SPECIAL PROVISION (ORNAMENTAL STREET LIGHT)

PROJECT NAME: BARRE CITY
 PROJECT NUMBER: FECC F 026-(K34) C/2
 FILE NAME: z85b010bdr_if_C2
 PROJECT LEADER: G. BAKOS
 DESIGNED BY: D. PECK
 STREET LIGHTING PLAN #1
 PLOT DATE: 3/23/2011
 DRAWN BY: D. PECK
 CHECKED BY:
 SHEET 79 OF 339

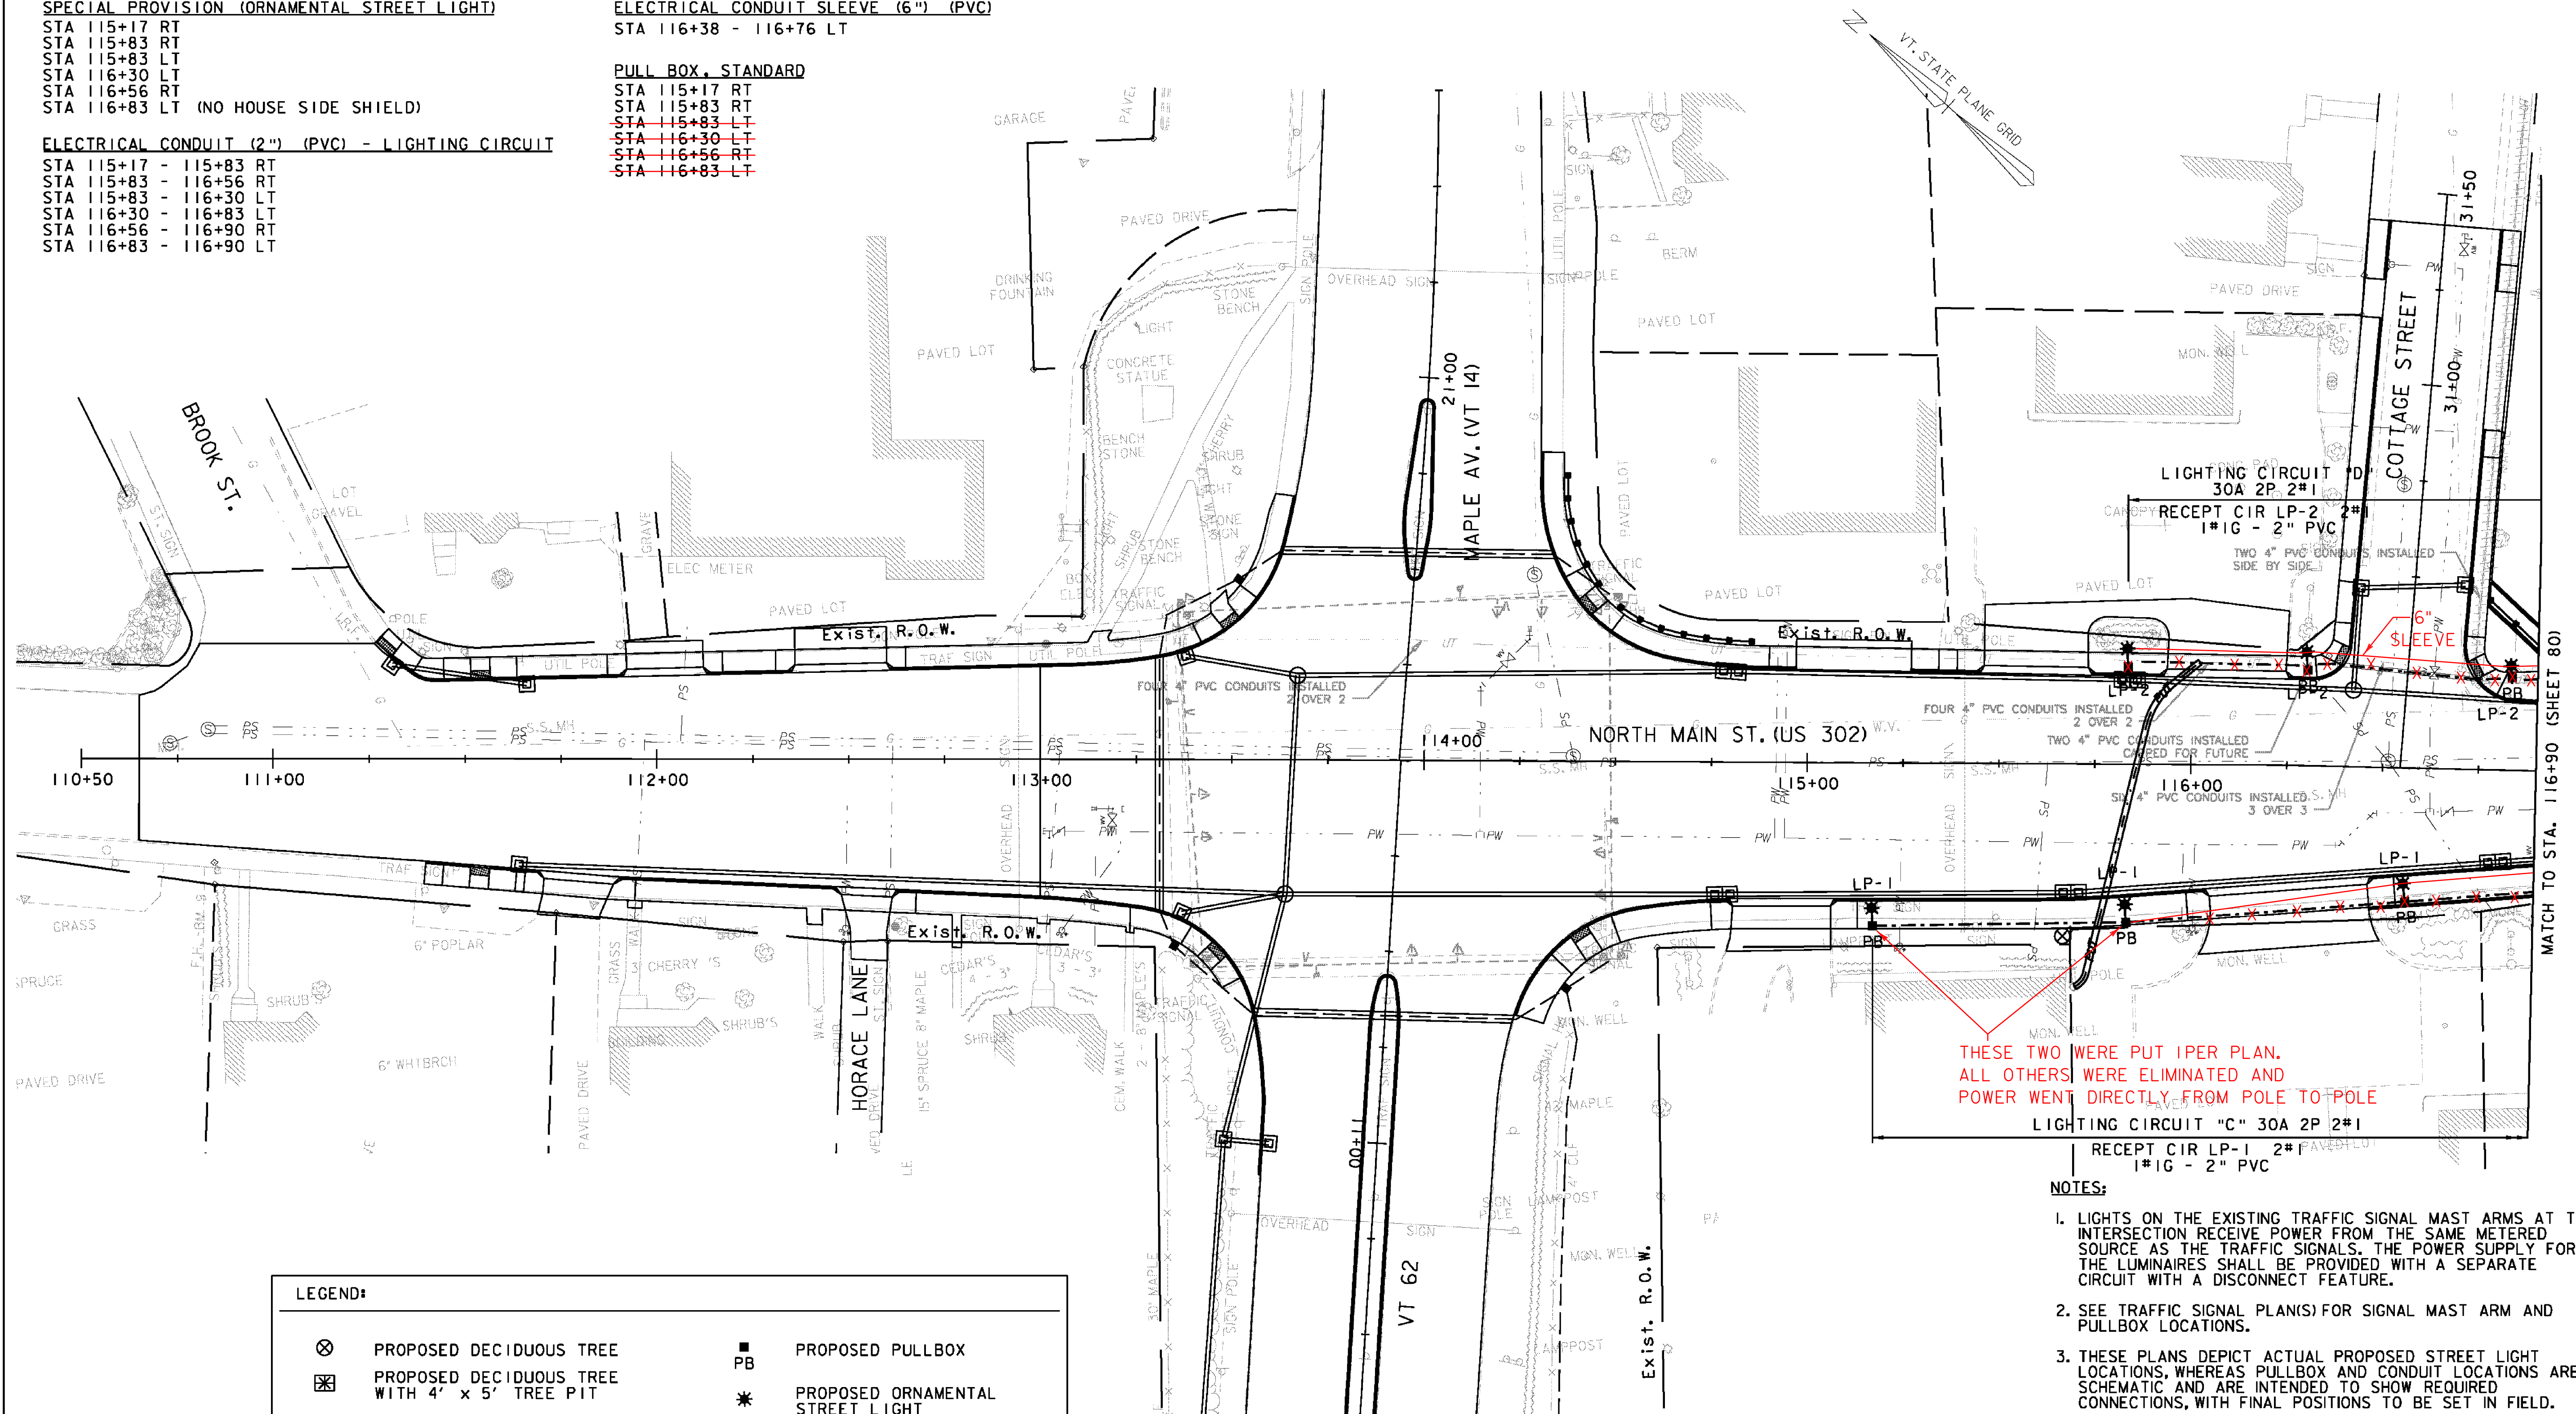
STA 115+17 RT
 STA 115+83 RT
~~STA 115+83 LT~~
~~STA 116+30 LT~~
~~STA 116+56 RT~~
~~STA 116+83 LT~~

THESE TWO WERE PUT I PER PLAN.
 ALL OTHERS WERE ELIMINATED AND
 POWER WENT DIRECTLY FROM POLE TO POLE
 LIGHTING CIRCUIT "C" 30A 2P 2#1
 RECEPT CIR LP-1 2#1
 1#1G - 2" PVC
